PLAN REVIEW CENTER REPORT

Planning Review

Taco Bell

Preliminary Site Plan

C0.1

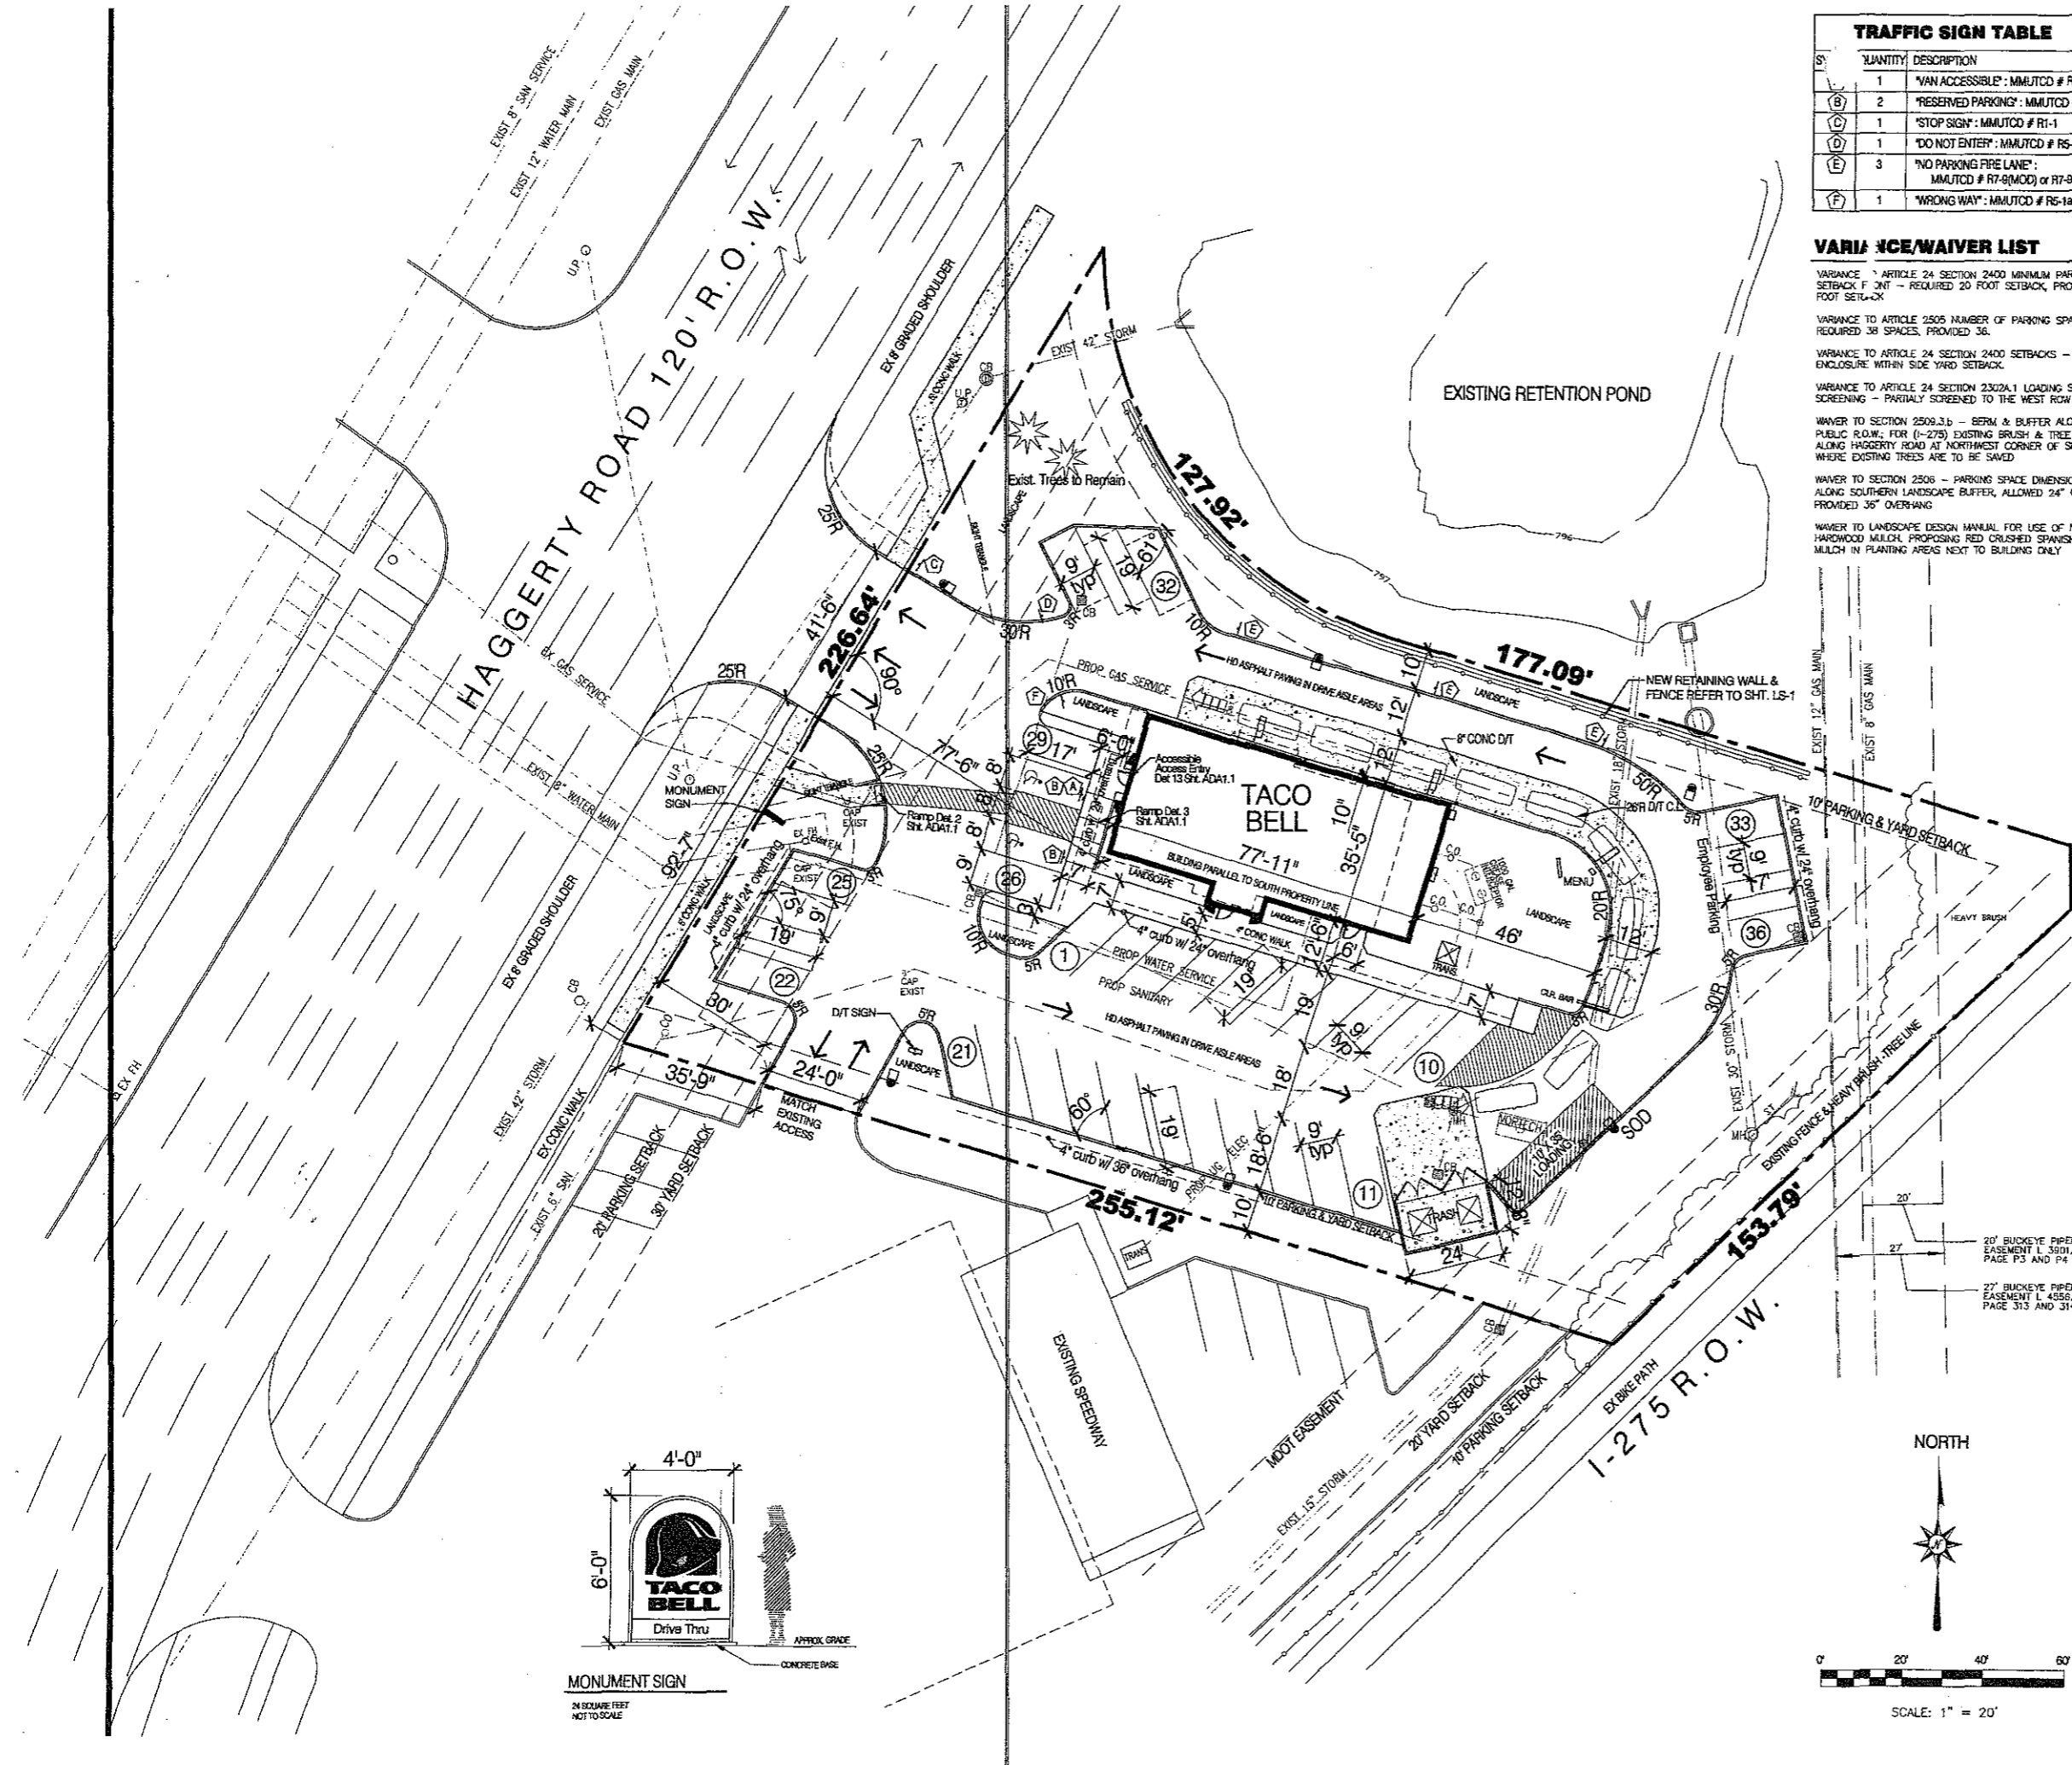
1. **Parking Setback:** In the FS district, the front yard parking setback is twenty feet. The proposed plan indicates a front yard parking setback of ten feet. The Planning Commission did state in the October 24, 2007 meeting minutes that they would not be opposed to seeing parking spaces included in this location. **The applicant should adjust the site layout to accommodate the front yard parking setback or seek a variance from the Zoning Board of Appeals.**

2. **Number of Parking Spaces:** Thirty-eight parking spaces are required per the standards set forth in Section 2505 of the Zoning Ordinance. Thirty-six spaces have been provided. Previously, the parking standard for a fast food restaurant (which requires considerably more spaces) was applied to this site. Per the direction of the Planning Commission, and based on representations of the volume of business typically found at this Taco Bell, the parking standard for a drive-through restaurant was applied for the revised Preliminary Site Plan. However, the applicant is still two spaces short of the required number of spaces. **The applicant should add two additional spaces or seek a variance from the Zoning Board of Appeals**

3. **Loading Zone Screening:** In the FS district, view of loading and waiting areas must be shielded from rights of way and adjacent properties. **Screening should be increased on the western property boundary or the applicant should seek a variance from the Zoning Board of Appeals.**

4. **Dumpster Enclosure:** The dumpster enclosure must be setback the same as parking (ten feet from the interior side yard). The proposed dumpster is setback five feet from the side yard (southern) property line. The relocation and subsequent side yard setback deficiency is the result of the redesign of the rear of the site so as not to encroach on the MDOT easement. **The applicant should adjust the site to accommodate the required side yard setback or seek a variance from the Zoning Board of Appeals.**
